SITE AUDIT REPORT

REMEDIAL ACTION

PLAN, ASPECT

INDUSTRIAL ESTATE,

Figure 3 - RAP Remediation Requirements

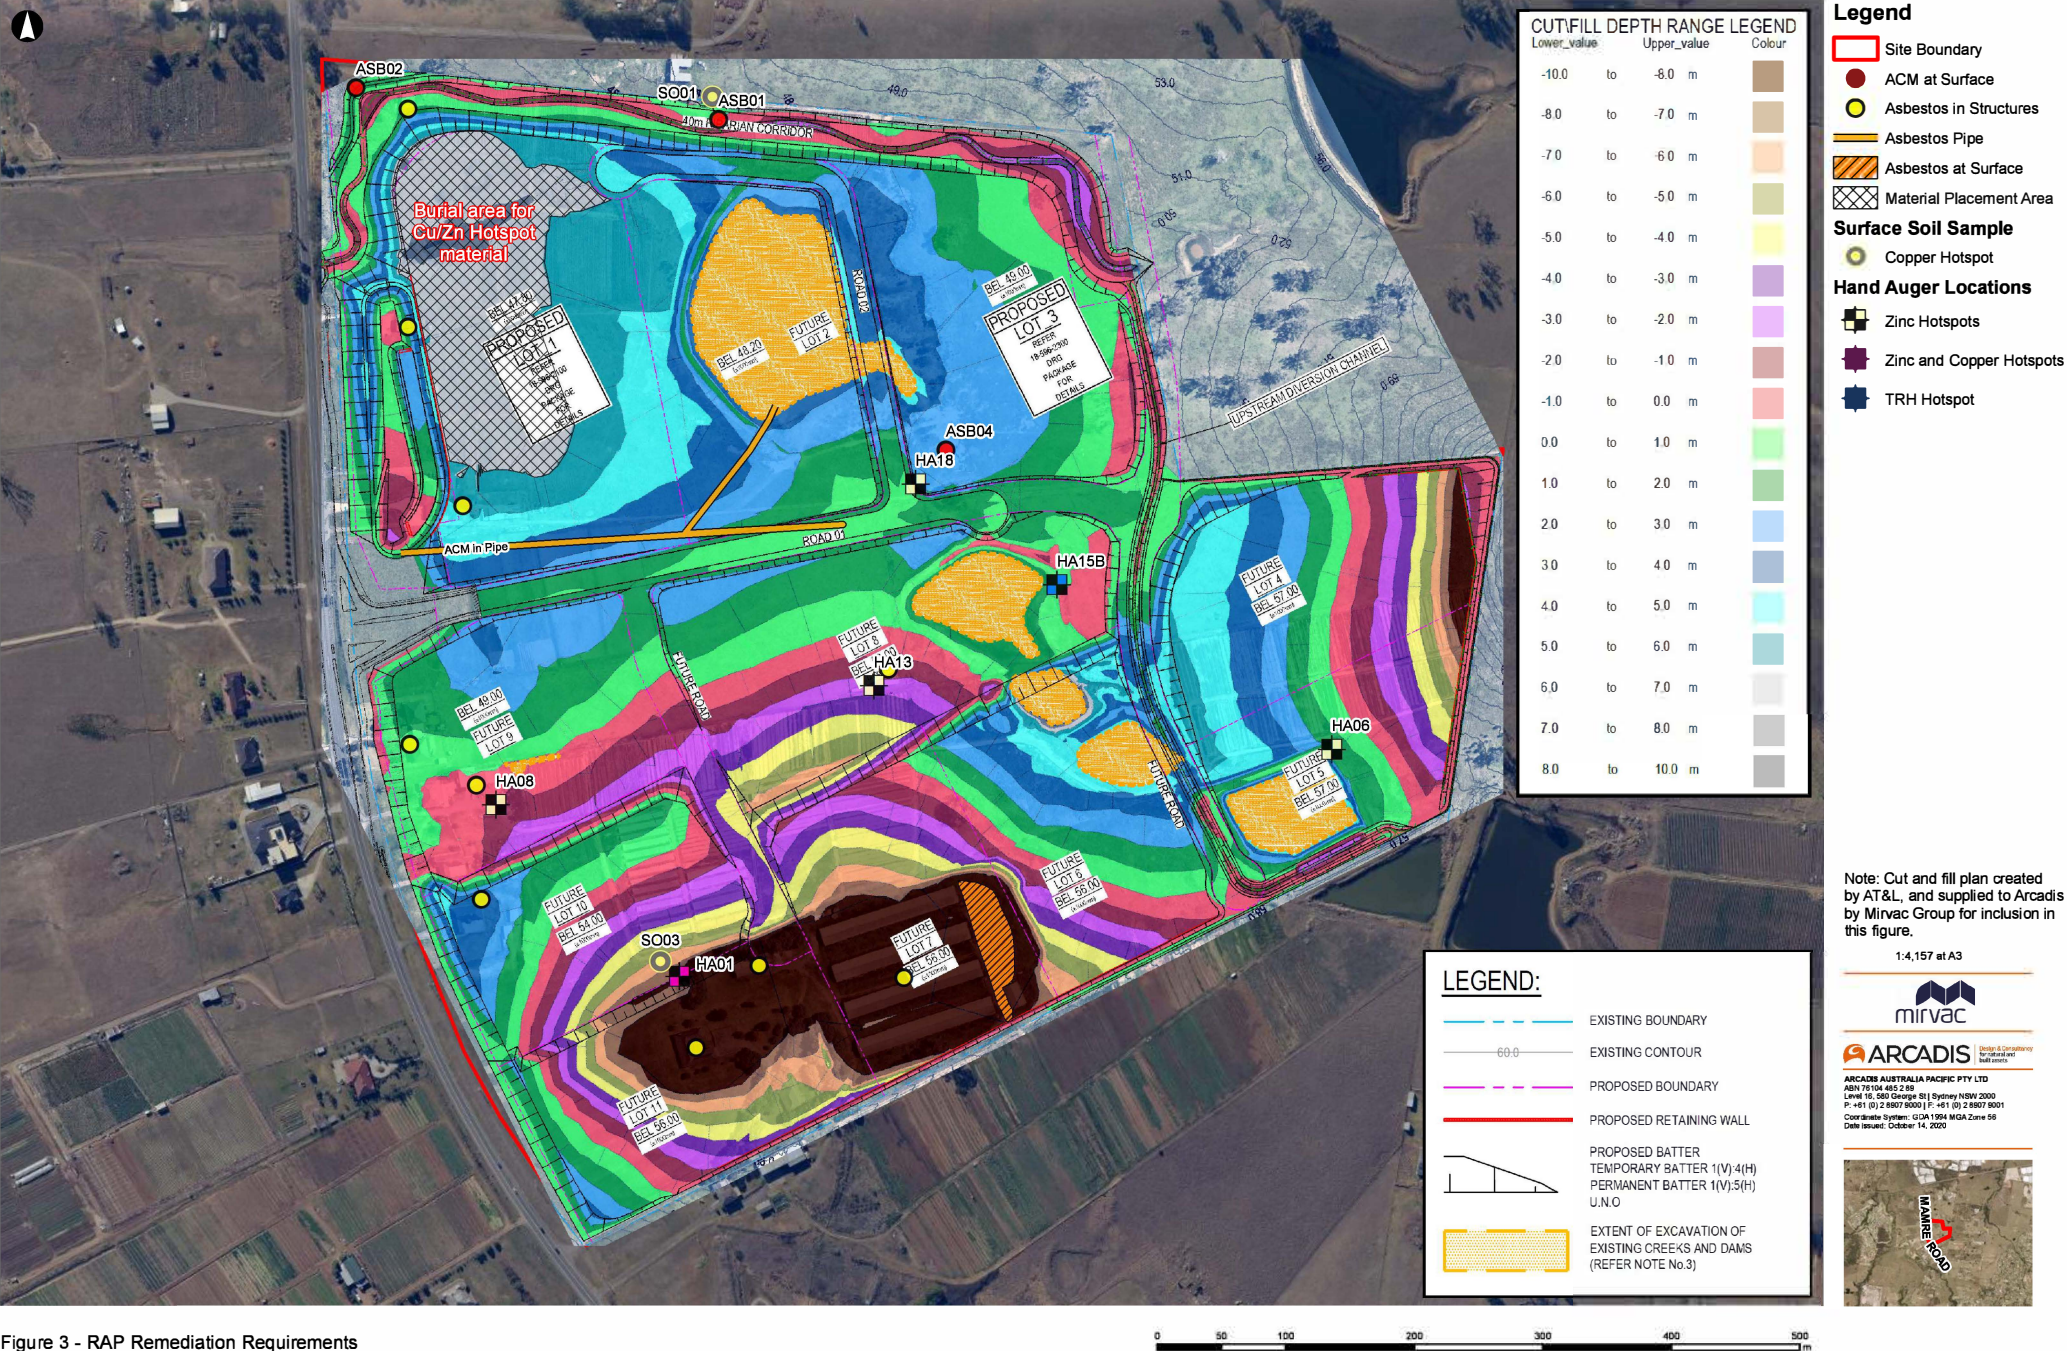
A summary of proposed remedial actions presented in the RAP is provided in Figure 10.1. The remediation areas are shown on Attachment 10, Appendix A.
